Date: August 2, 2017
To: Jason Gilman, Sara Olson
From: Kevin Luecke
Re: South Avenue Multimodal Assessment Steering Committee Meeting #4

South Avenue Multimodal Assessment Steering Committee Meeting
Friday, August 4, 2016
11:00am – 12:30pm
City Hall 3rd Floor Conference Room

PRELIMINARY DRAWING
 RECOMMENDED ALTERNATIVE
 MINIMUM WIDTH WITH ROUNDABOUTS
 US 14 IMPROVEMENTS
 CITY OF LA CROSSE, SOUTH AVENUE
 GREEN BAY STREET TO WARD AVENUE
 LA CROSSE COUNTY
 WISDOT PROJECT ID 1641-02-02
JULY 2017

Date: June 27, 2017
To: Jason Gilman and City of La Crosse Staff
From: Kevin Luecke
Re: WisDOT South Avenue Designs and Recommendations

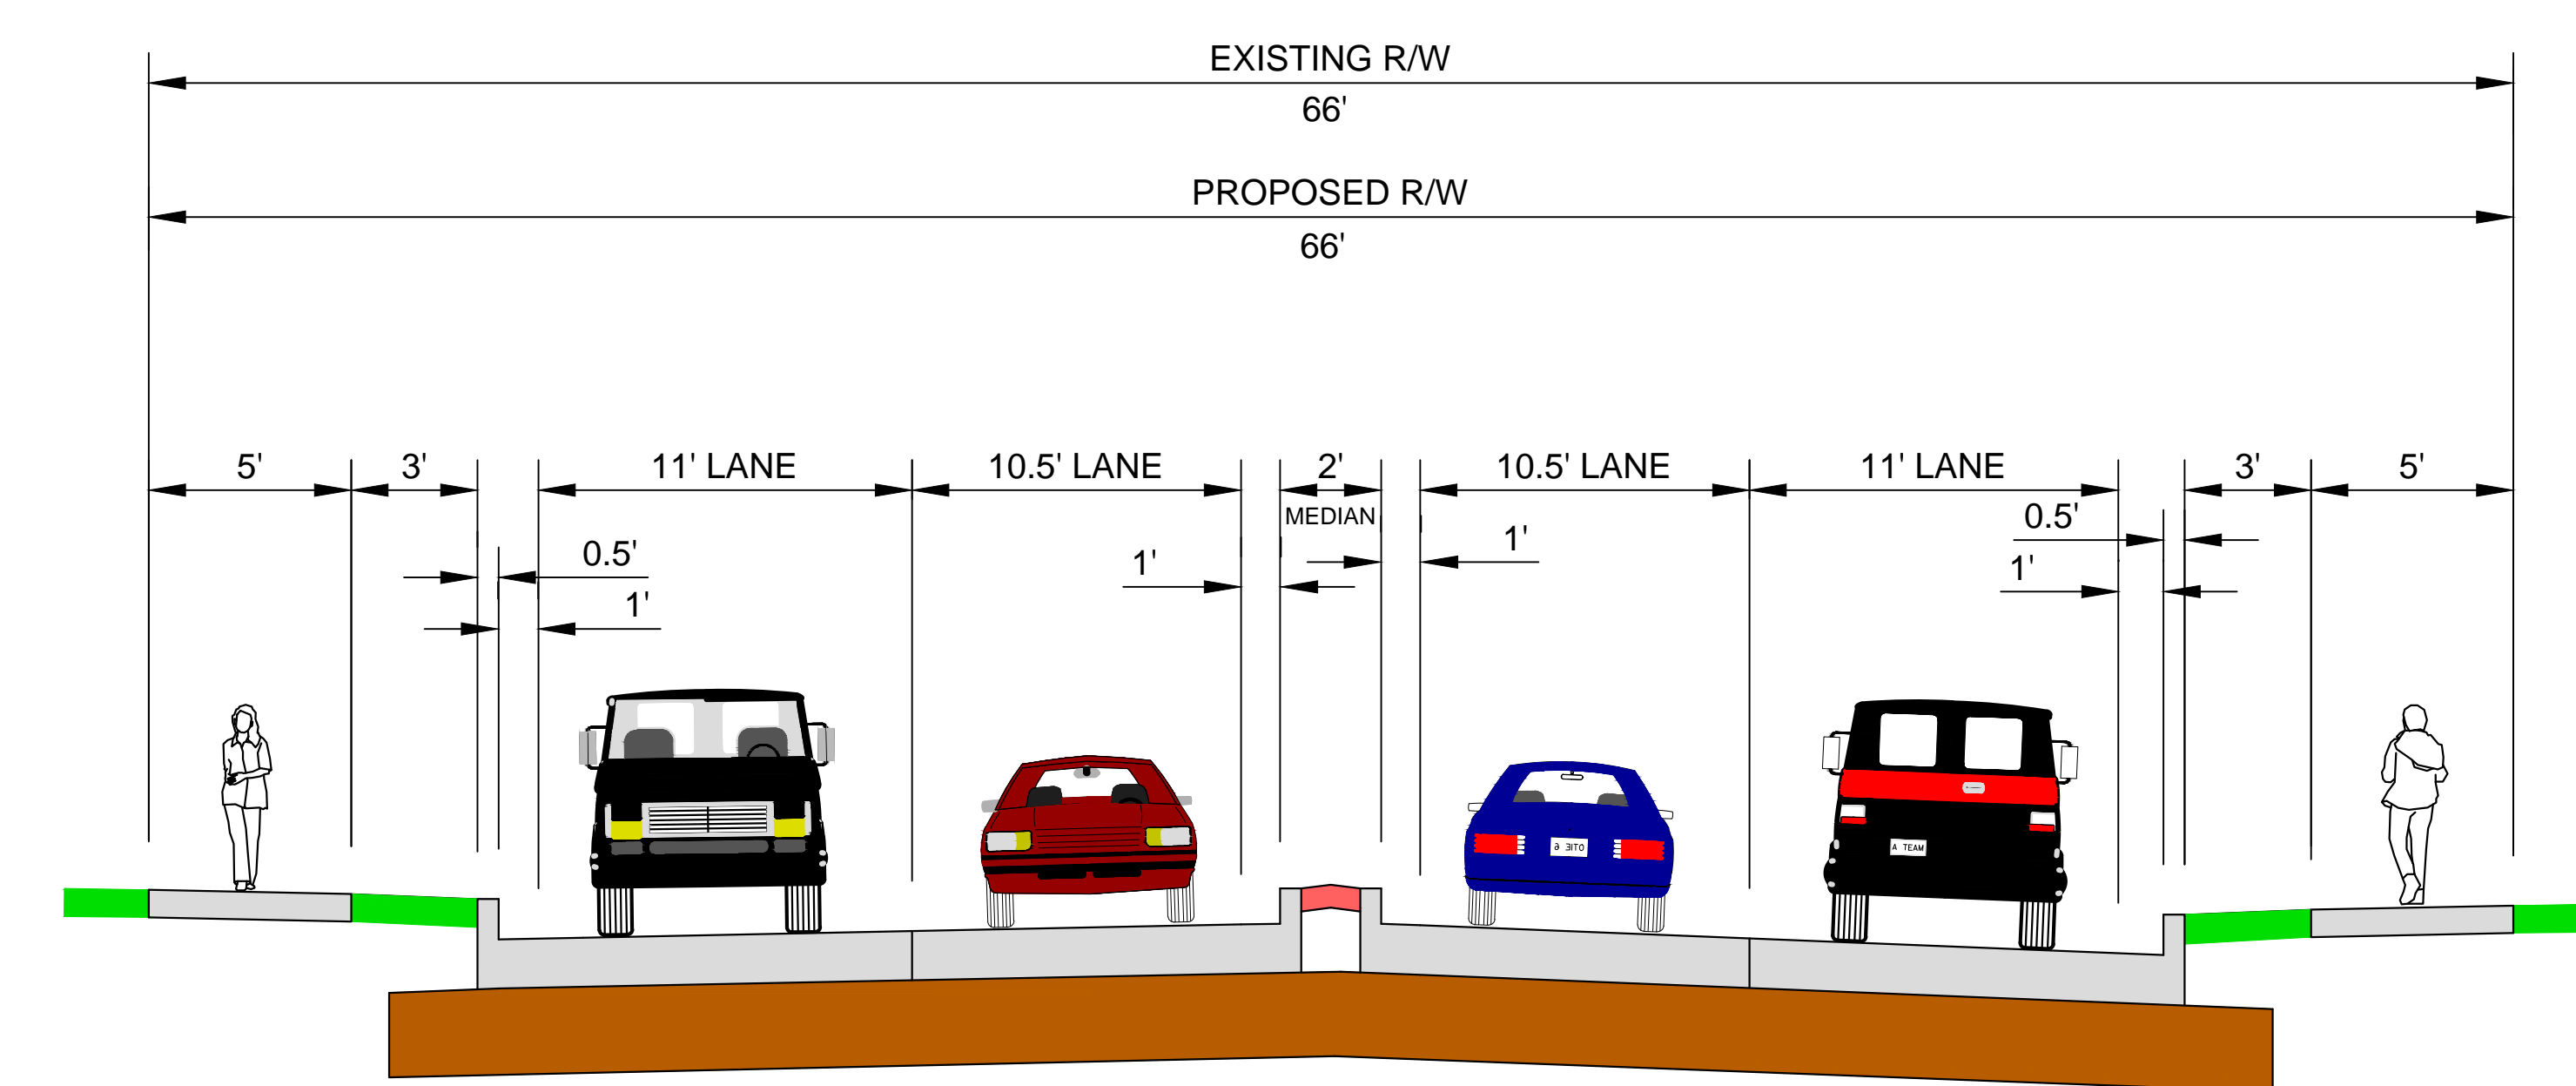
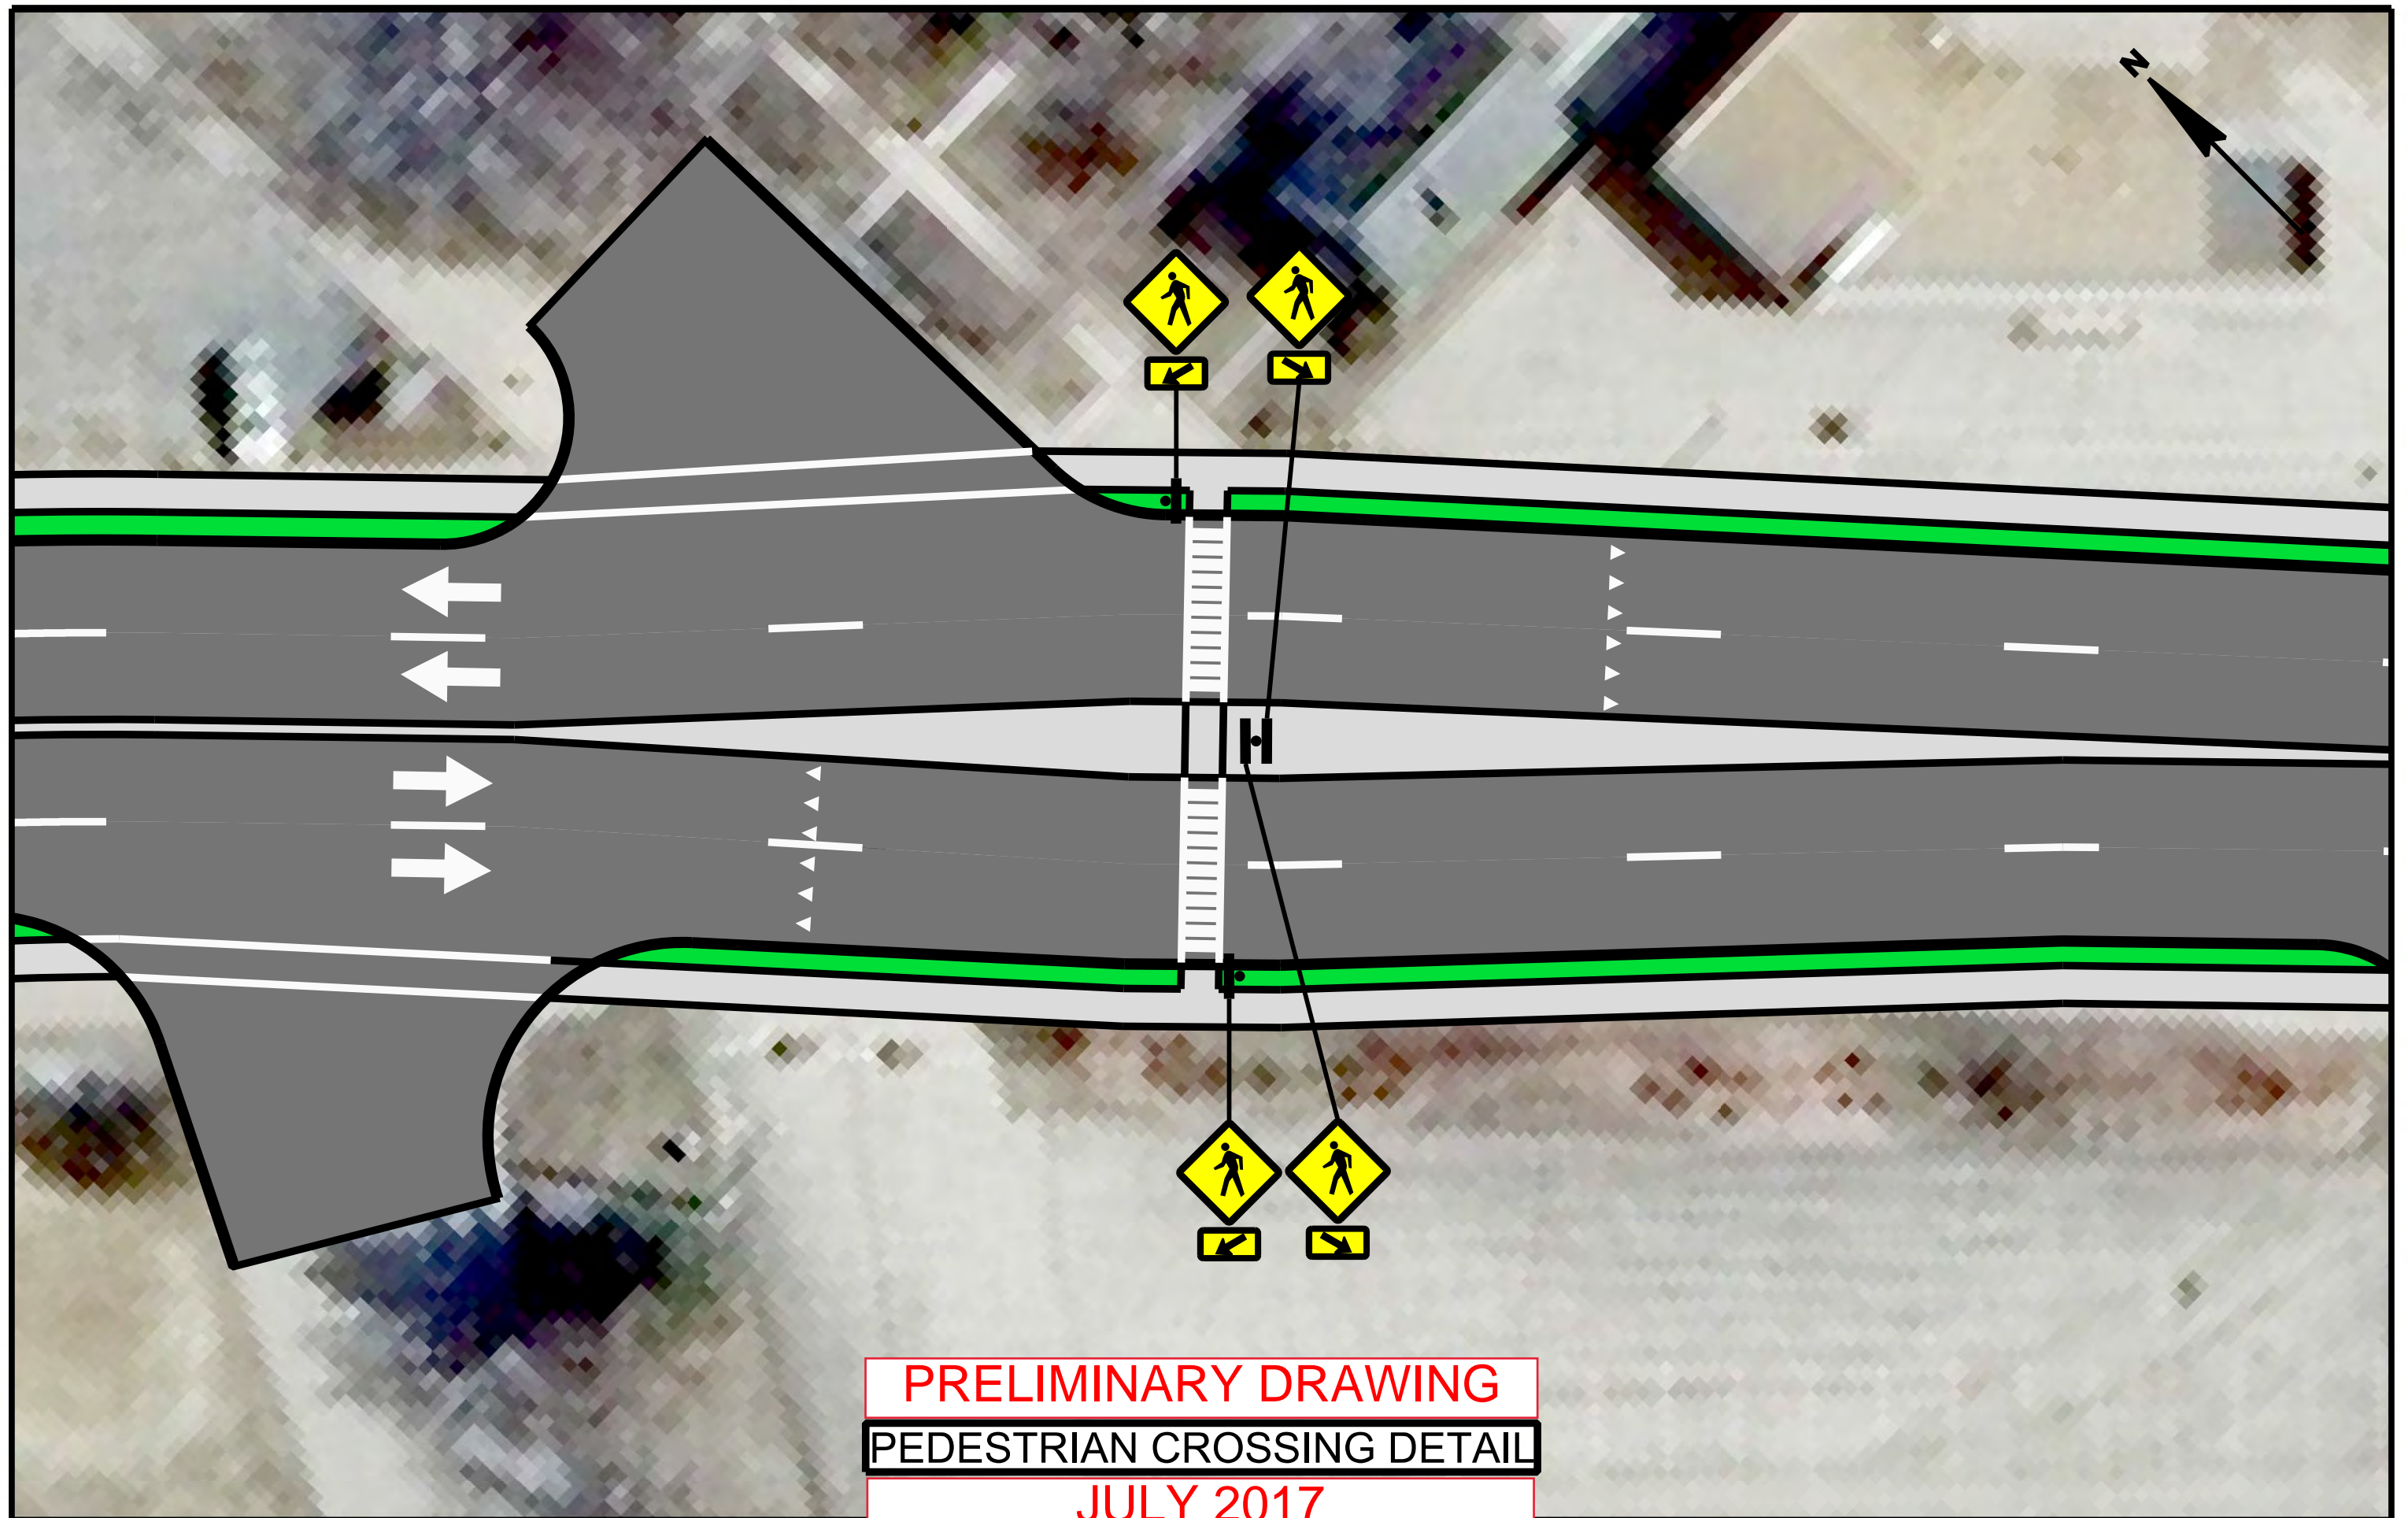
Of the alternatives developed by WisDOT, Alternative 1 is preferable due to the alternative's narrow footprint which minimizes impacts on surrounding properties. However, there are significant issues with the proposed design and the City may be better served by pushing for a reduction to three lanes. The remainder of this section highlights issues identified with Alternative 1.

Alternative 1 does not provide bicycle facilities, either on or adjacent to South Avenue. While bicycling on the sidewalk is allowed in this area of La Crosse, the proposed 5-foot wide sidewalk is not adequate for bicycling, and sidewalk bicycling is not a safe practice in environments with many street and driveway crossings.

Long crossing distances present safety issues for pedestrians and bicyclists. Each lane of traffic that a pedestrian or bicyclist crosses is a potential conflict point. Whether crossing at a traffic signal or at an uncontrolled location, shorter crossings are better for pedestrian and bicyclist safety. Alternative 1 eliminates all controlled crossings of South Avenue within the study area.

Alternative 1's provision of a continuous center median will eliminate motor vehicle access to properties and streets on the left side of the street from the vehicle. To access streets or properties on the left side of the street, motorists will need to either use the roundabout before their destination to access local streets, or will need to overshoot their destination, travel fully around the next roundabout, and return to their destination.

The proposed continuous center median between roundabouts in Alternative 1 will eliminate left-turn access and crossings at many points on South Avenue. While this may be desirable from a crash safety perspective, it will limit access by emergency responders and may lengthen emergency response times.

Eliminating left turns on South Avenue using a continuous center median will likely result in increased motor vehicle speeds. This is due to traffic not be forced to slow or stop behind vehicles waiting to turn left and the loss of "side friction" between vehicles using the center lanes. Alternative 1 proposes narrowing the width of the travel lanes slightly from the existing conditions. Typically, narrowing travel lanes reduces motor vehicle speeds slightly. However, the increased speeds from addition of the continuous center median and the removal of traffic signals will likely more than offset the reduction from the narrowed lanes. Additionally, the roundabout design in Alternative 1 encourages high-speed exit from the roundabouts, which makes yielding to pedestrians less likely.

Figure 1: Alternative 1 utilizes "offset left" style roundabouts that decrease entry speed but allow for higher speed exit from the roundabouts. A symmetric design should be used to reduce both entry and exit speeds and improve yielding to pedestrians.

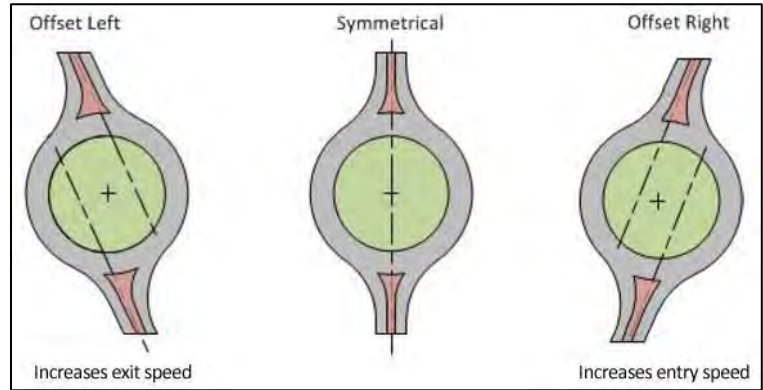
Use a symmetric roundabout design to limit traffic speed entering and exiting the roundabout.

The roundabouts in Alternative 1 are designed to limit the speed of traffic entering each roundabout. However, the offset design allows drivers to accelerate out of the roundabout. This is problematic for pedestrians attempting to cross the exit leg of a roundabout, as faster traffic is unlikely to yield to pedestrians.¹ All roundabouts on South Avenue should use a symmetric design relative to South Avenue to limit both the entering and exiting speeds of motorists. A symmetric design will improve yielding behavior of motorists to pedestrians crossing the street. Symmetric roundabouts may also reduce some of the right-of-way impacts necessitated by the installation of roundabouts.

Figure 4: The risk of pedestrian serious injury or fatality in a crash with a motor vehicle increases dramatically between 20 and 40 miles per hour.

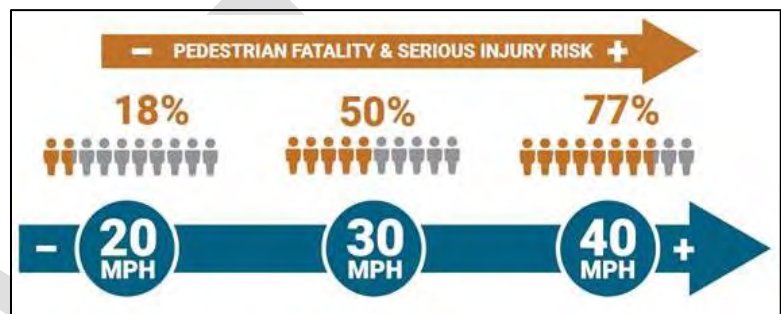
Use a speed limit of 25 miles per hour and a design speed of no more than 30 miles per hour when designing the street.

The risk of pedestrian serious injury or fatality rises significantly as motor vehicle speeds increase above 20 miles per hour. Every effort should be made to reduce the travel speed on South Avenue in recognition of its status as an urban street with active pedestrian uses.

The speed limit on South Avenue should be set to 25 miles per hour. Additionally, when designing the street, the design speed used should ideally be 25 miles per hour. Using a design speed greater than the intended speed for the street will result in traffic speeds above the posted speed limit.
